RE: **Lot 28 Block 6 Unit 22, S.A.D. 228**
Volcano Cliffs Subdivision
6531 Pato Rd. NW
Grading and Drainage Plan
Engineers Stamp Date 1/10/19 (D10D003M28)

Based upon the information provided in your submittal received 1/11/19, this plan is approved for Grading Permit.

6531 PATO RD. NW, ALBUQUERQUE, NM 87120				NEW MEXICO	
CITY OF ALBUQUERQUE, BERNALILLO COUNTY					
LOT 28, BLOCK 6, UNIT 18 VOLCANO CLIFFS SUBDIVISION					
SOLIS, JAVIER (BUILDER: MICHAEL SANCHEZ) — G & D PLAN					
McDowell Engineering, Inc.					
7820 BEVERLY HILLS AVE. NE • ALBUQUERQUE, NM 87122					
TELE: 505-828-2430 • FAX: 505-821-4857					
Designed	JSM	Drawn	STAFF	Checked	JSM
File	SOLO118L		Date	DECEMBER,2018	
				1	1

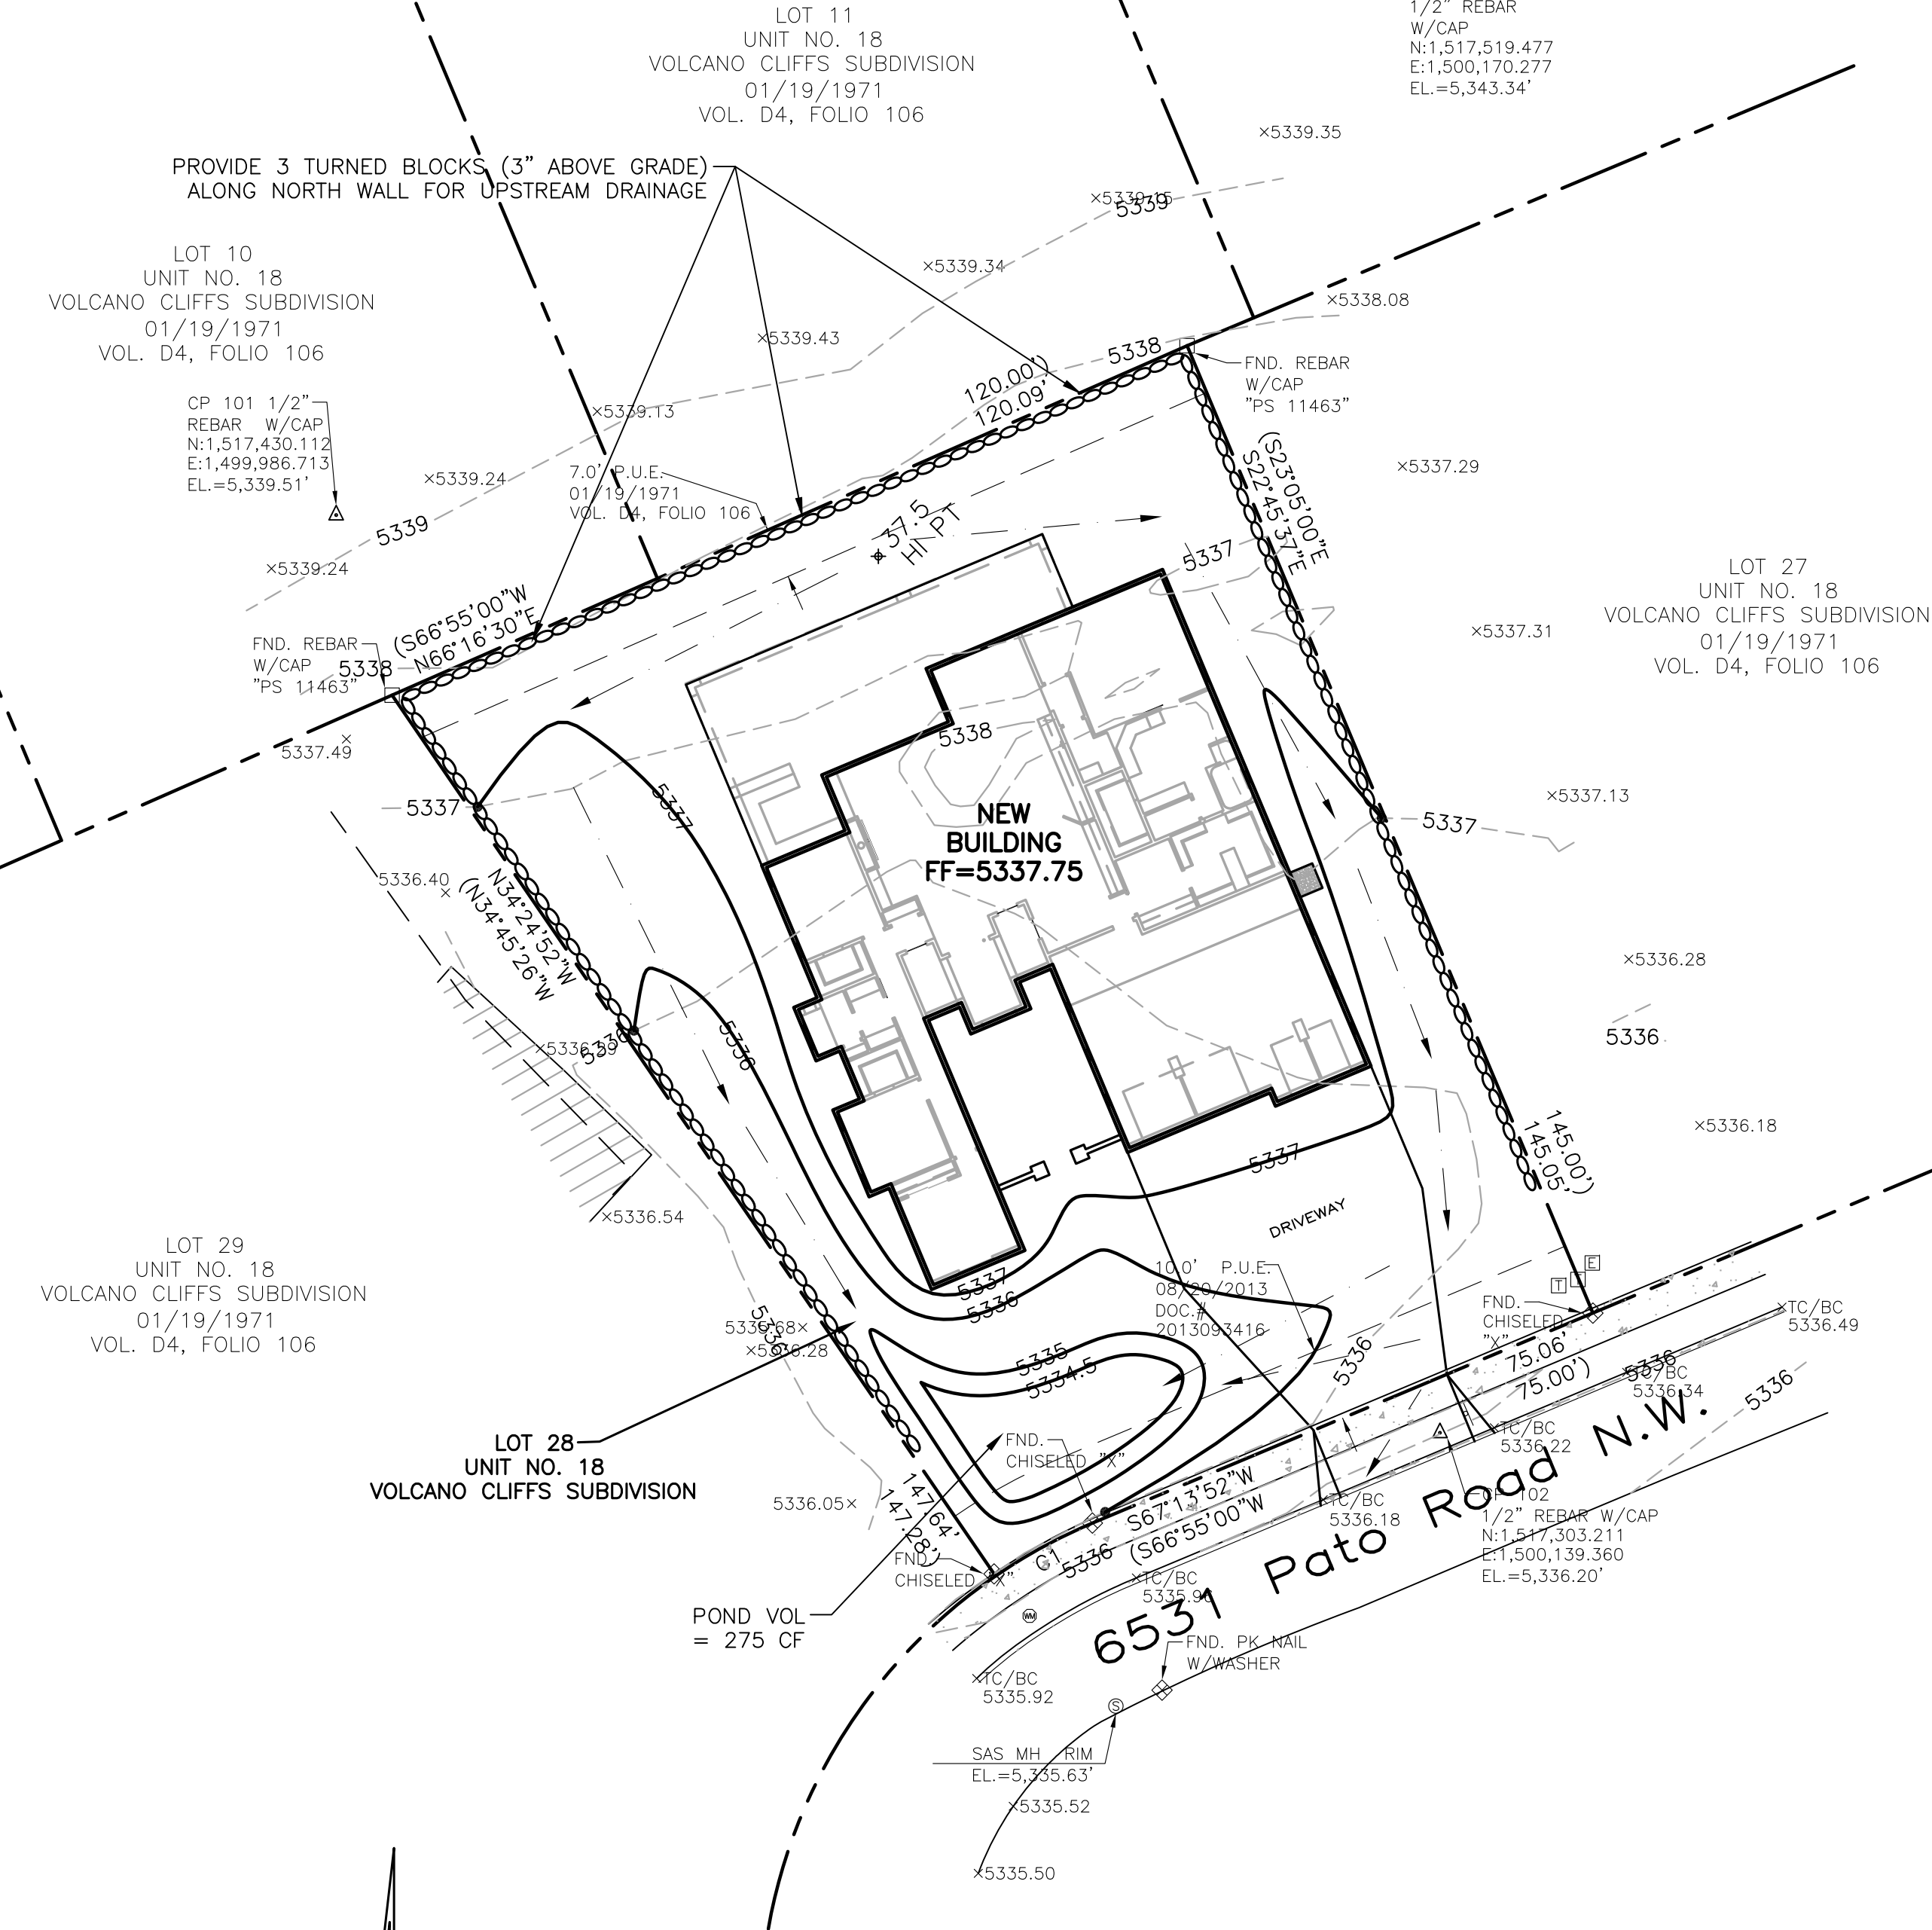
Reiterate to the Owner/Contractor that a separate permit for a garden/retaining wall must be obtained, with the approved G&D plan dated 5/17/18.

This is the plan to be used for any garden walls and any openings in the walls shall be placed 3" above final grade in the rear yard to allow for cross lot drainage from west to east (upstream to downstream).
